Applicant : Perry R. DeYoung
Appn. No. : 09/586,943
Page : 8

REMARKS

FIG. 1

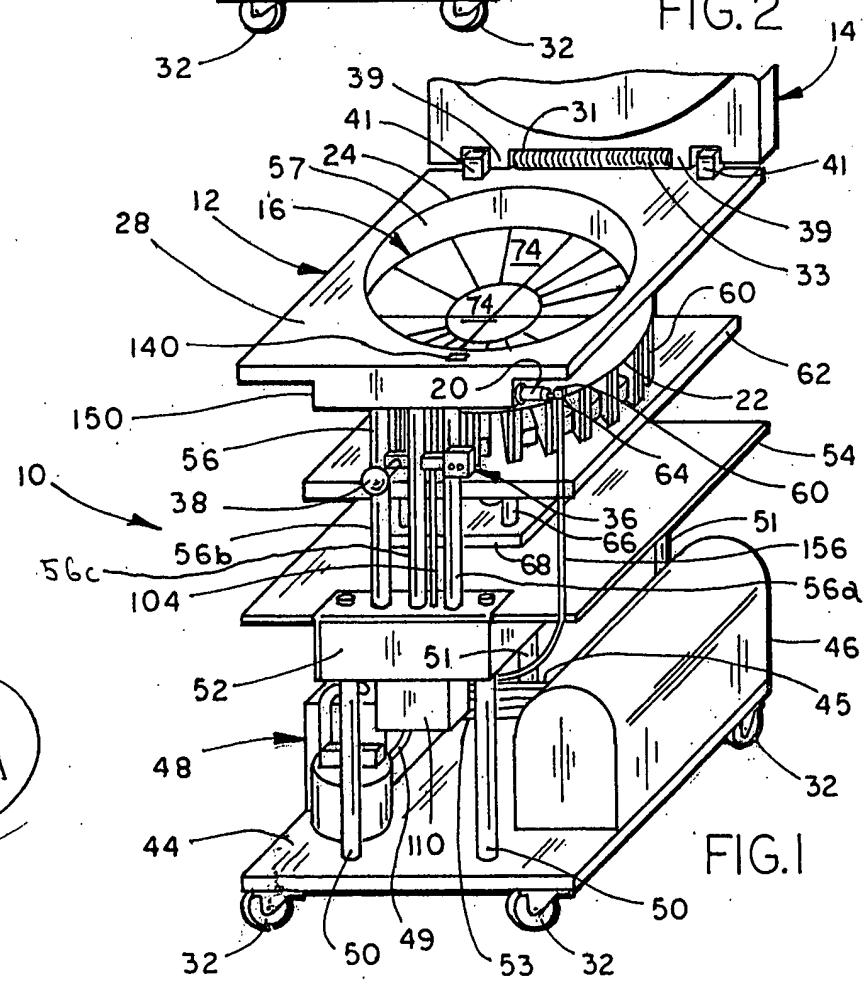
Fig. 1 has been objected to because it is not clear as to whether the center vertically-extending structure between structures 56a and 56b is also a support. The Examiner suggested that numeral 56c along with a lead line should be added to indicate the central support for clarity. Applicant respectfully submits a marked-up copy of Fig. 1 showing the numeral 56c added in red ink for the Examiner's review. Applicant has also added a sentence on page 7 of the specification to refer to the front middle upper support 56c.

The illustrated dough divider 10 also includes the hopper 12 at a top end which is connected to the middle rectangular plate 54 by several upper supports 56. The hopper 12 includes an annular wall 57 with the rectangular flange 28 integral with the top of the annular wall 57. In the illustrated example, seven upper supports 56 with a hexagonal cross-section,

three in the front of the main housing body 26 and four in the back of the main housing body 26, are located between the middle rectangular plate 54 and the rectangular flange 28 of the hopper 12. The switch housing 36 is attached to a front right upper support 56a and the control valve handle 38 is attached to a front left upper support 56b and the front right upper support 56a. A front central support 56c is located between the front left upper support 56b and the front right upper support 56a. A dough dividing assembly 58 is located between the middle rectangular plate 54 and the hopper 12. As explained in more detail below, the dough dividing assembly 58 compresses the dough and divides the dough into equal portions.
